**Central Zoo Authority**

F. No. 19-114/92-CZA(271)(Vol. IV)(M) / 4715

**Sub:- Designs for the construction of various enclosures at Pt. G. B. Pant High Altitude Zoo, Nainital.**

**PROPOSED ADDITION TO THE  
EXISTING ENCLOSURE FOR  
PHEASANTRY AT- PT. G.B. PANT  
HIGH ALTITUDE ZOO NAINITAL  
(SCALE- 1:150)**

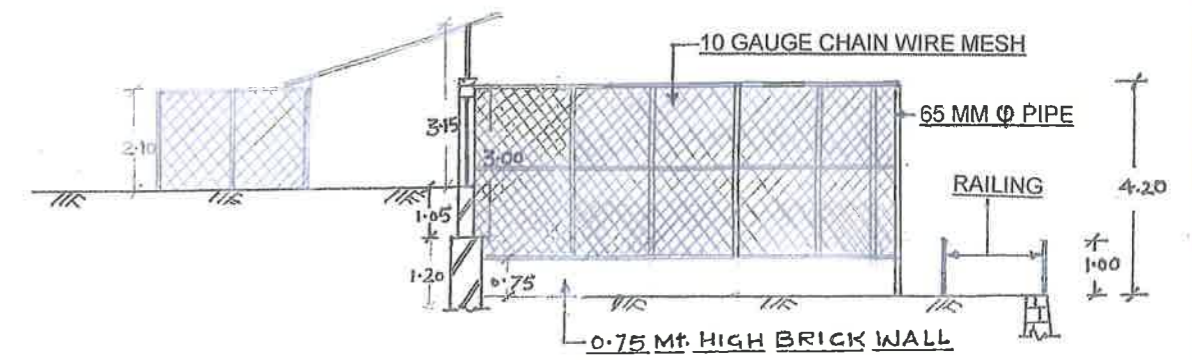
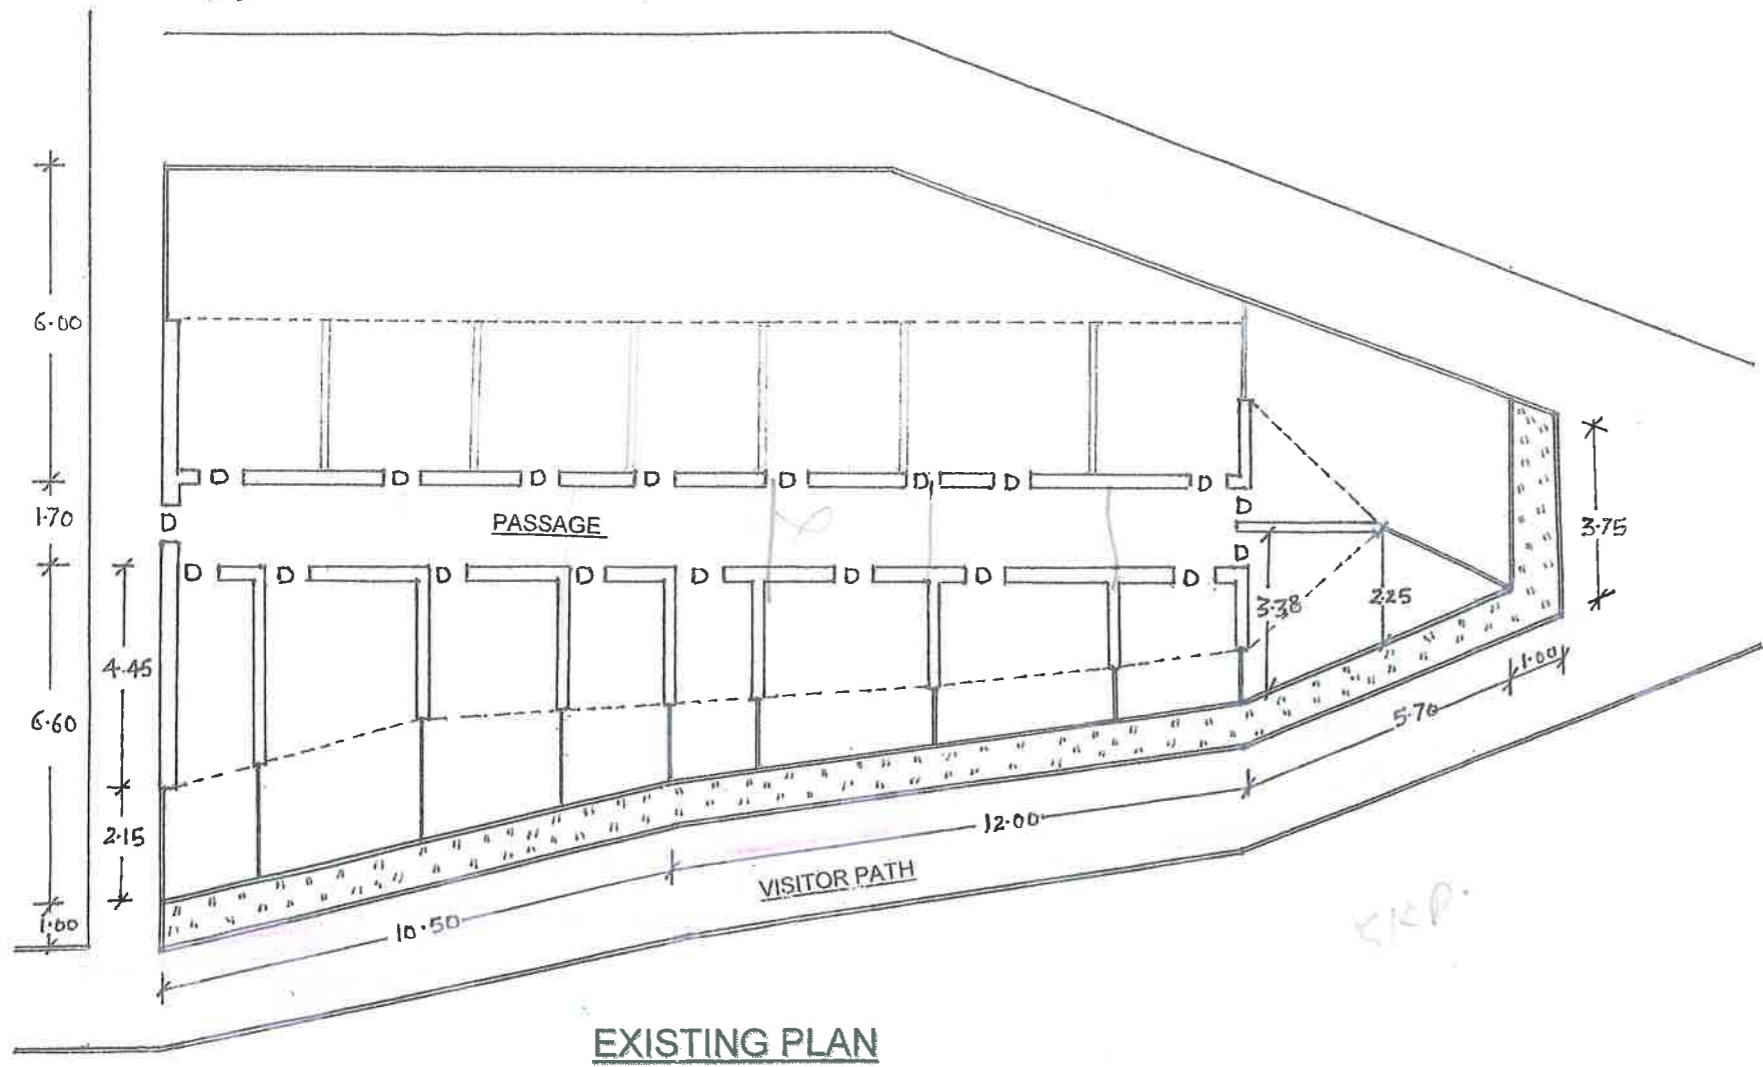
1. Revised design of Pheasantry

The revised design was scrutinized and approved.
